**CALENDAR ITEM
C73**

**CONSIDER AMENDMENTS TO BALLAST WATER PERFORMANCE STANDARDS
REGULATIONS TO ESTABLISH PROTOCOLS FOR THE EVALUATION OF
COMPLIANCE WITH CALIFORNIA BALLAST WATER DISCHARGE STANDARDS**

TEXT OF MODIFIED REGULATIONS

**Title 2, Division 3, Chapter 1,
Article 4.7 Performance Standards and Assessment Protocols for the Discharge
of Ballast Water for Vessels Operating in California Waters**

Figure 1. Sampling port components and dimensions

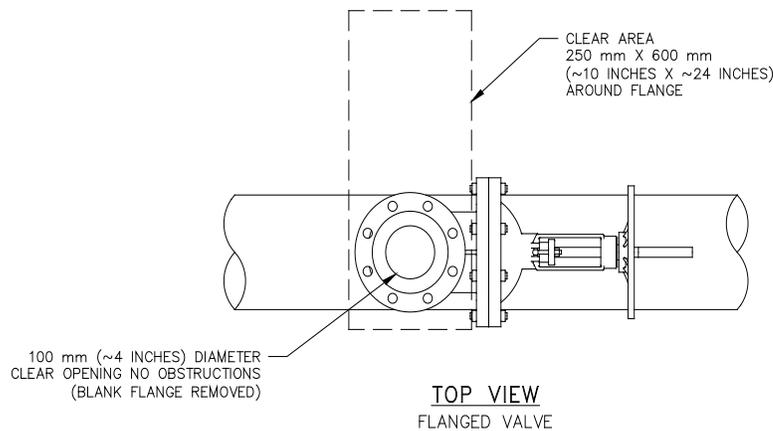
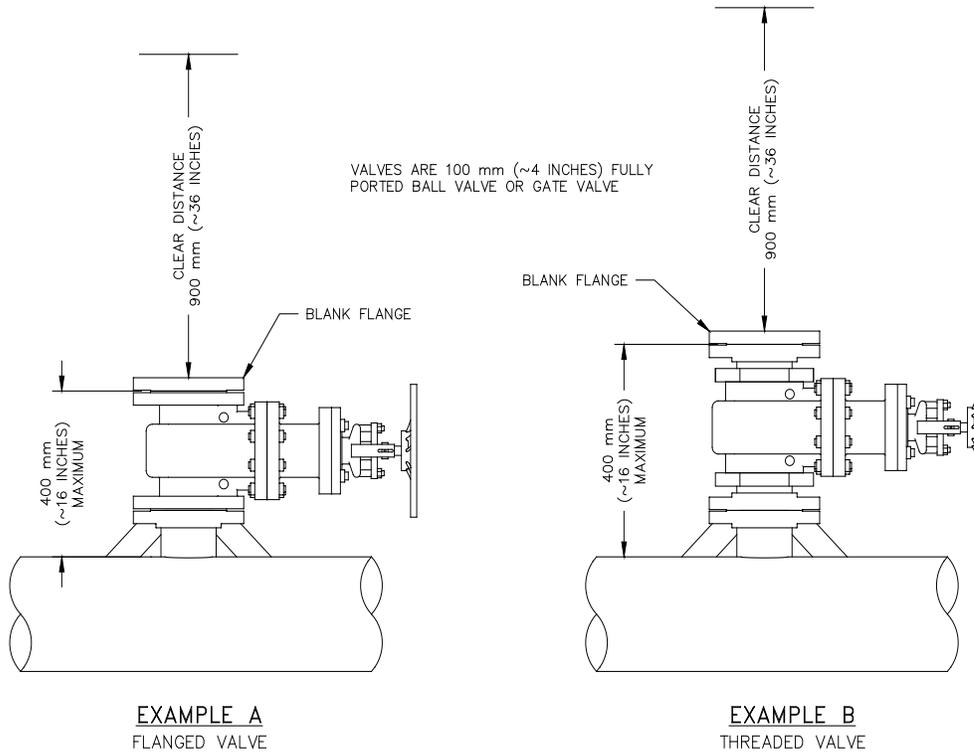
1) The sample port(s) provided by the vessel shall consist of a piping connection into the ballast main, a shut-off valve, and a flange. All other sampling and test equipment is to be provided by the Commission staff performing the sampling and testing.

A) 1) ~~The sampling facility shall not damage and/or induce substantial incidental mortality to organisms to be collected in ballast water.~~ The sampling port shall provide clear access into the ballast water main pipeline.

Sample port size shall be based on the combination of maximum sample flow rate and minimum ballast flow rate that yields the largest isokinetic diameter. All sample port components shall be at least four inches (100 mm) in nominal dimension and comply with the materials schedule of the existing ballast water system.

C) 3) The opening of the sampling pipe shall be chamfered to provide a smooth and gradual transition between the inside and outside pipe diameters. The sample port shall consist of the following components (see Figure 1 – Sampling port components and dimensions):

i. A branch connection, using a tee fitting, pipe boss, saddle, or other approved method shall be used to access the inside of the ballast water main pipeline. The inside of the access shall be unobstructed by the ballast main pipe, internal edges filed smooth, and de-burred.

ii. An isolation valve that meets marine vessel regulatory requirements as mandated by the relevant flag state and/or marine classification society shall be provided to allow the sample port to be closed off from the ballast main pipeline. The isolation valve shall be fully ported, such that a clear and straight opening equal to the pipe inside diameter is provided from the access flange into the ballast main. Suitable valves include fully ported ball valves and gate valves. Butterfly, globe, and similar valves that do not provide a clear and straight opening are not acceptable.

iii. An access flange shall be provided to allow connection of Commission equipment to the access port. The access flange shall be of standard design such as ANSI B16.5 or DIN equivalents. It is acceptable to utilize a flanged isolation valve as the access flange. The access flange must be paired with a blank flange, gasket, and bolting suitable to close the sample port. The access flange must be maintained such that Commission gaskets can fit tightly when sampling equipment is attached.

iv. The distance from the ballast main pipe inside diameter to the face of the access flange shall not exceed 400 millimeters (mm) (approximately 16 inches).

v. A minimum of 900 mm (approximately 36 inches) of clear operating area above the access shall be available for the attachment of Commission sampling equipment.
